CHAPTER 8

Comments and Responses on the Draft EIR/EIS

Monterey Peninsula Water Supply Project . 205335.01
Figure 8.3.2-1
 ASR-1 Disinfection Byproducts Parameters

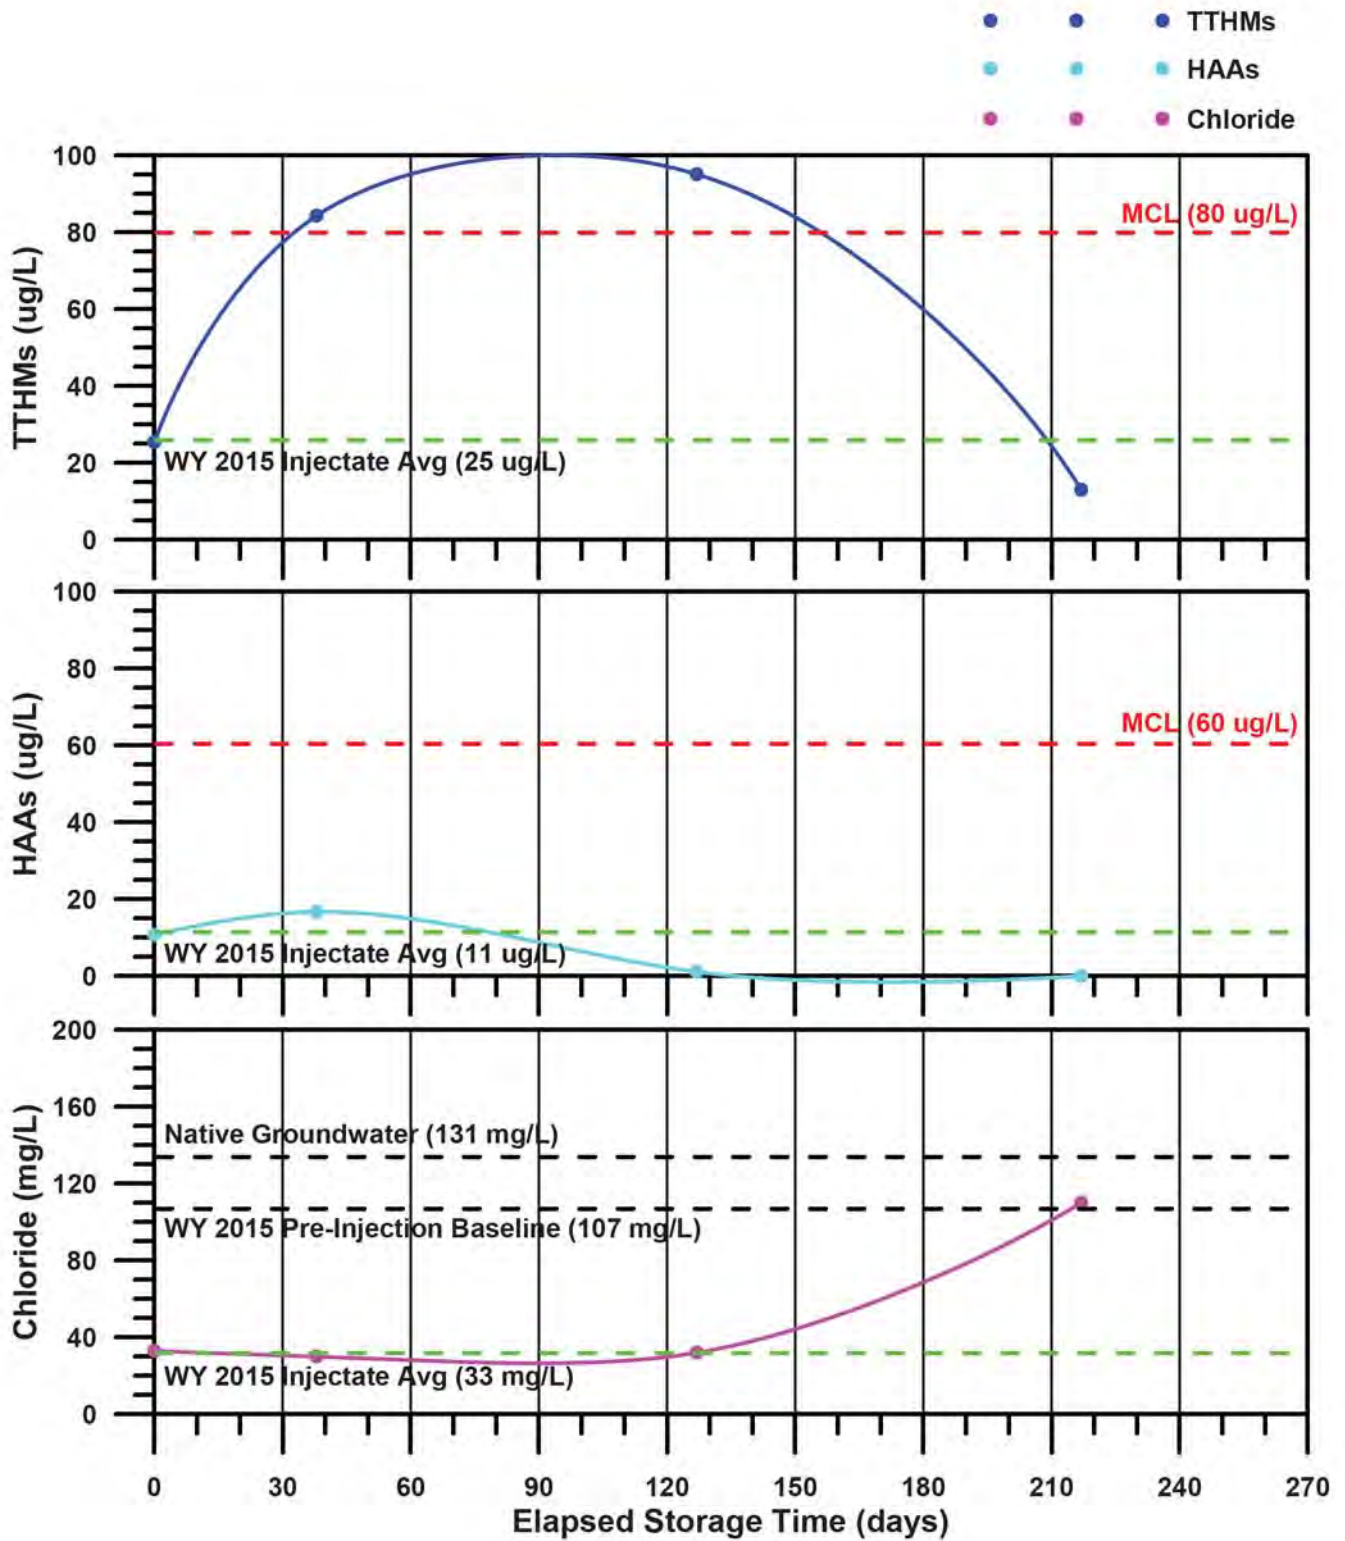
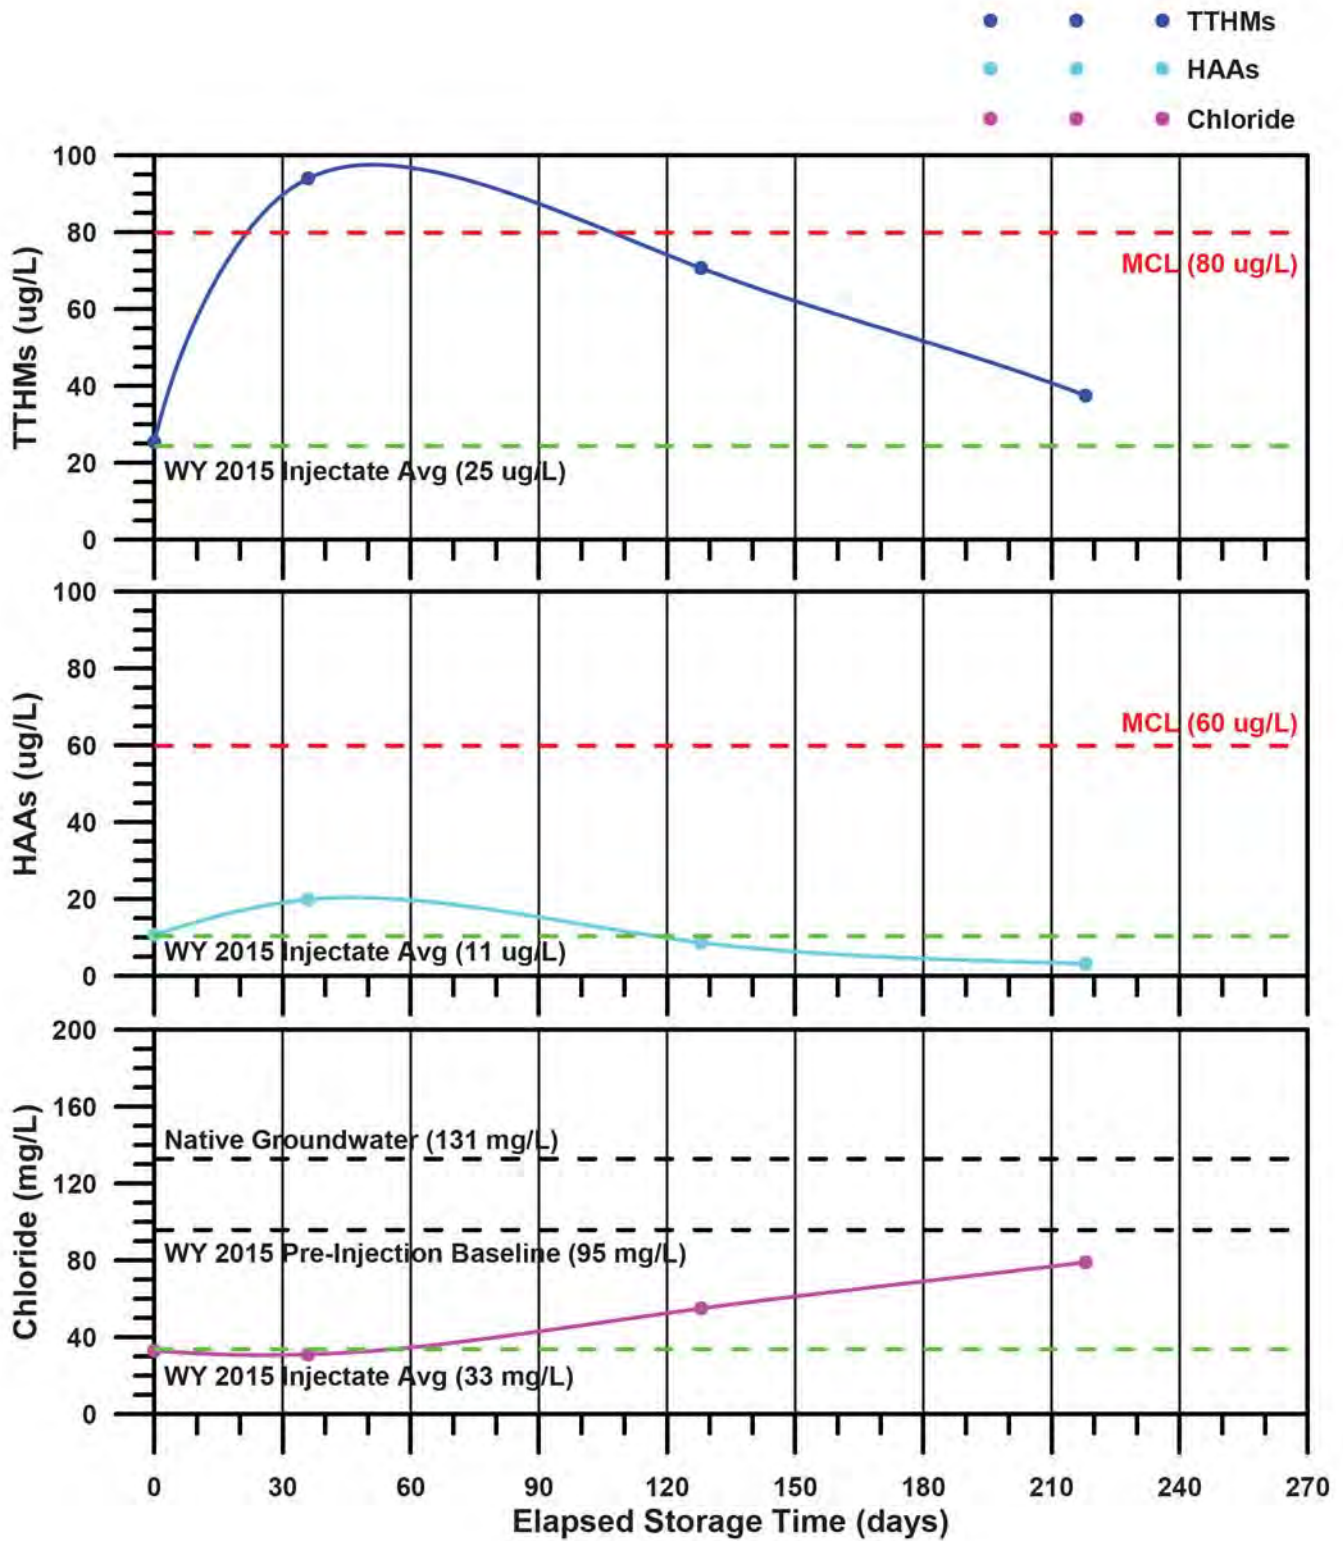
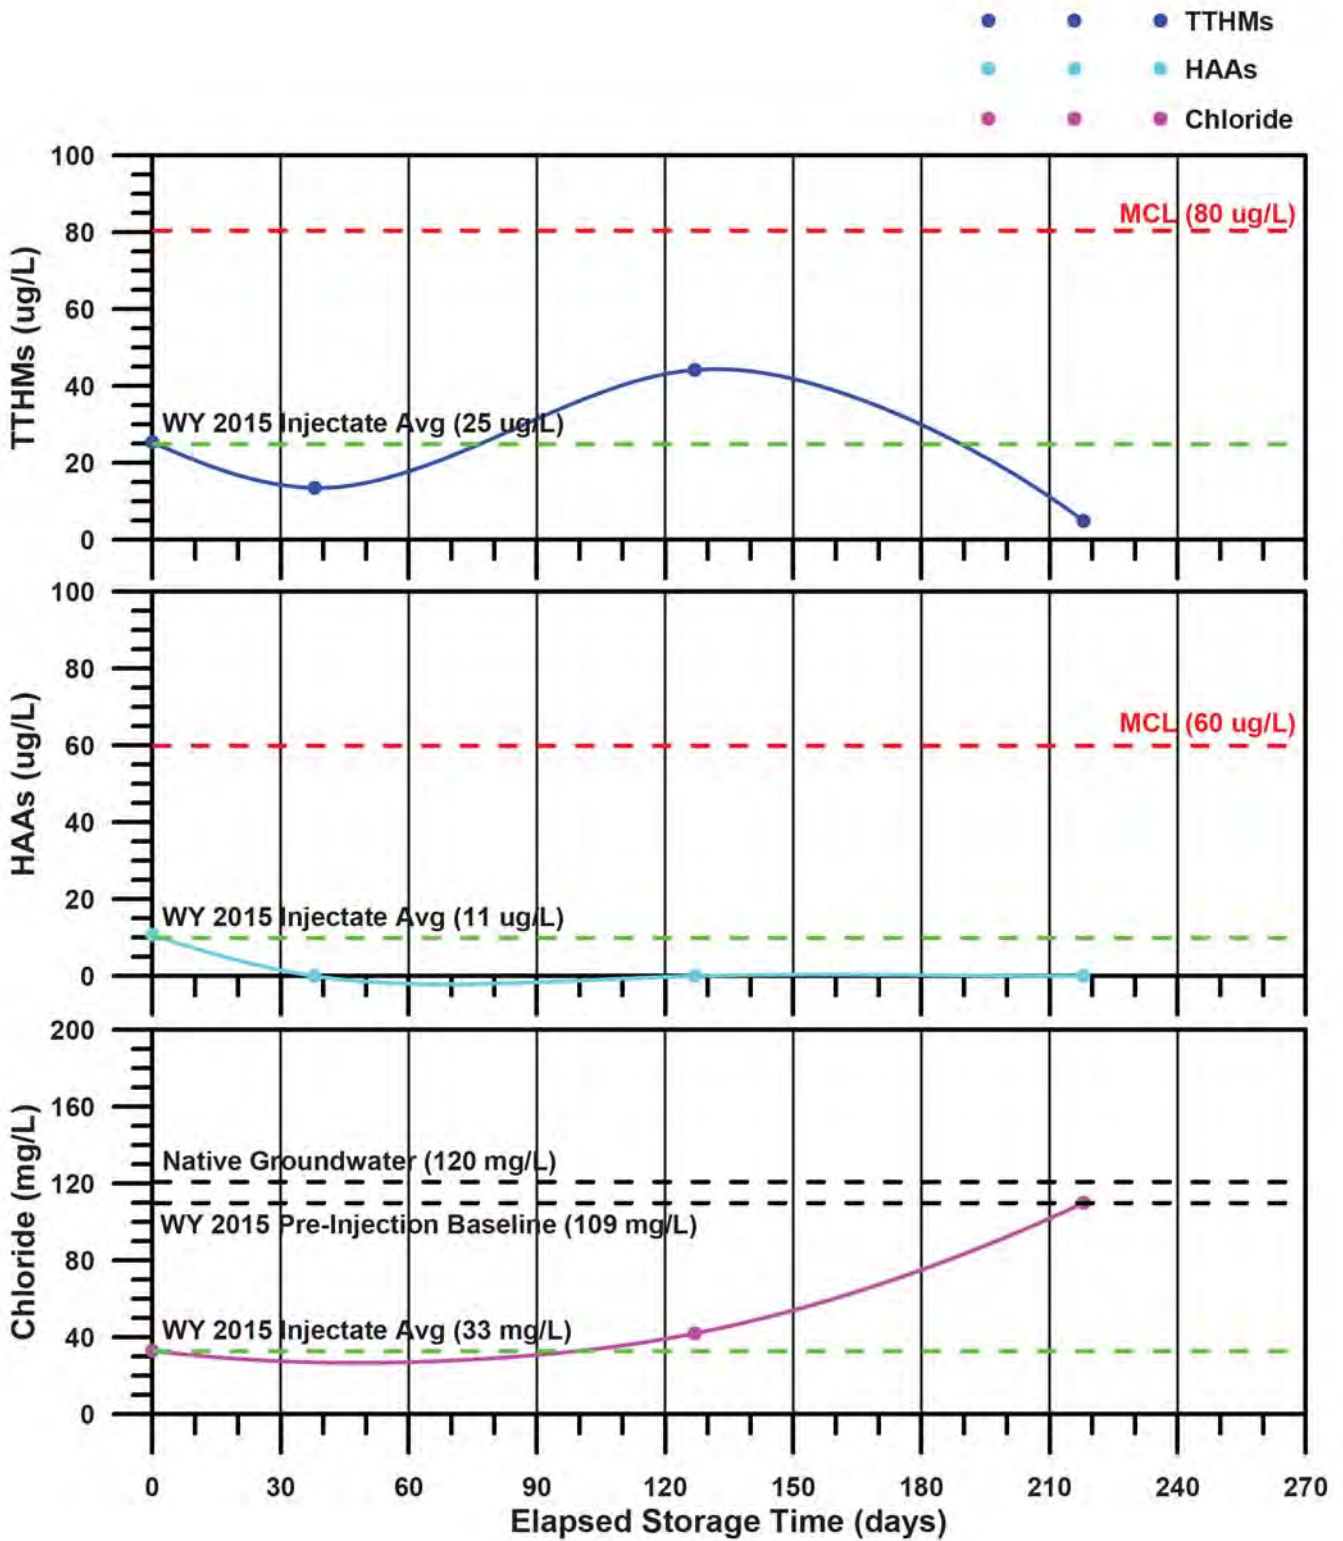
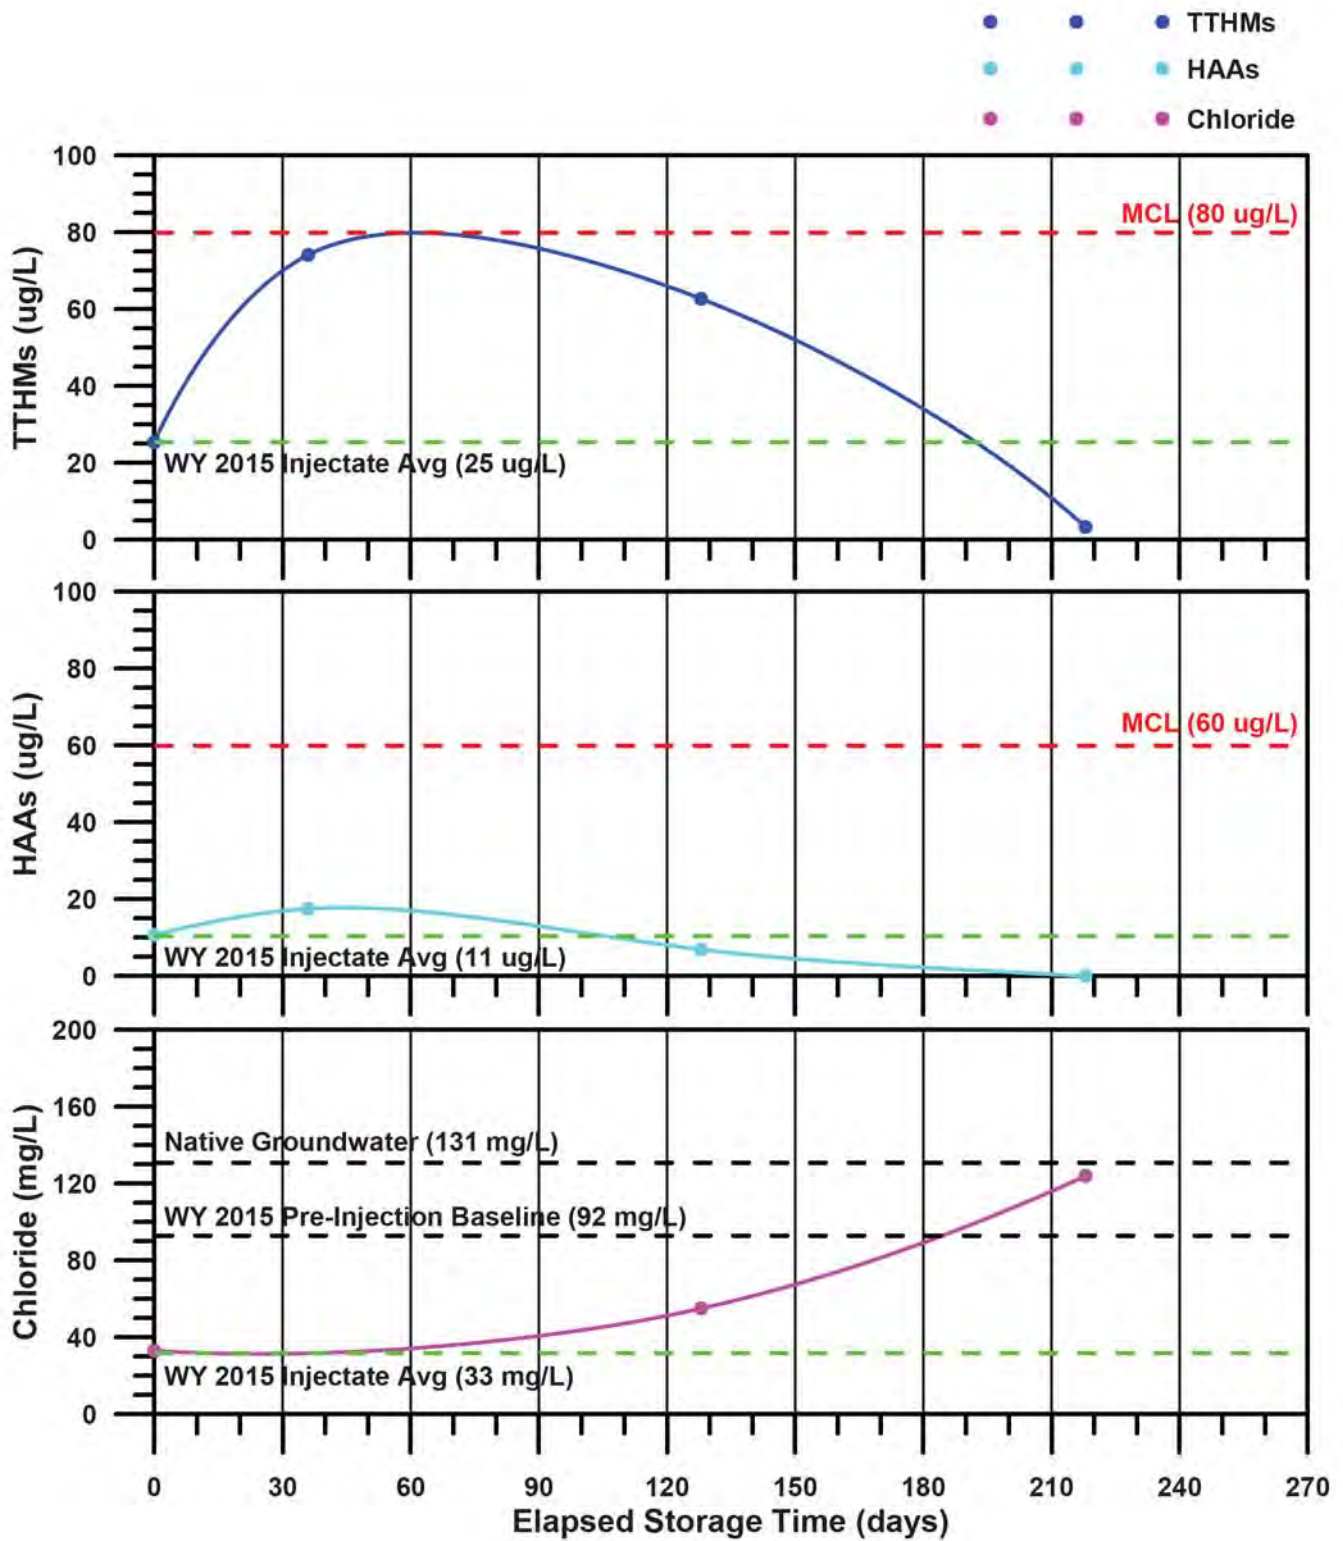
Section 4.4.1.4 states, “The Disinfection Byproducts (DBP) data collected during the 2015 water year indicated that trihalomethanes (THMs) peaked approximately 30 to 90 days after injection and storage, followed by a gradual decline. After approximately 150 to 210 days of storage, THMs had degraded to below the initial injection levels.” However, per the “Draft Summary of Operations Report for the Monterey Peninsula ASR Project, Water Year 2015”, dated June 2016, prepared by Pueblo Water Resources for the Monterey Peninsula Water Management District, Figure 22, it appears that THMs exceed the initial injection level after 210 days for the ASR-3 site. Please include a discussion that considers this data.

USARMY-14 The discussion of Disinfection Byproducts in Section 4.4.1.4 has been revised to reflect the cited information about past operation of existing ASR-3:

After approximately 150 to 210 days of storage, THMs in four out of the five wells monitored had degraded to below the initial injection levels. Although the concentration of THMs in the ASR-3 well had not yet reached the initial injection level as of 210 days, the concentration was exhibiting a continuing downward trend suggesting the initial injection concentration would be reached within about 240 days. HAAs degraded to below reporting limits by 90 to 100 days. More importantly, throughout the 2015 water year, after the initial increase following injection, THMs were below the MCL of 80 micrograms per liter and HAAs were below the MCL of 60 micrograms per liter in all five wells monitored.
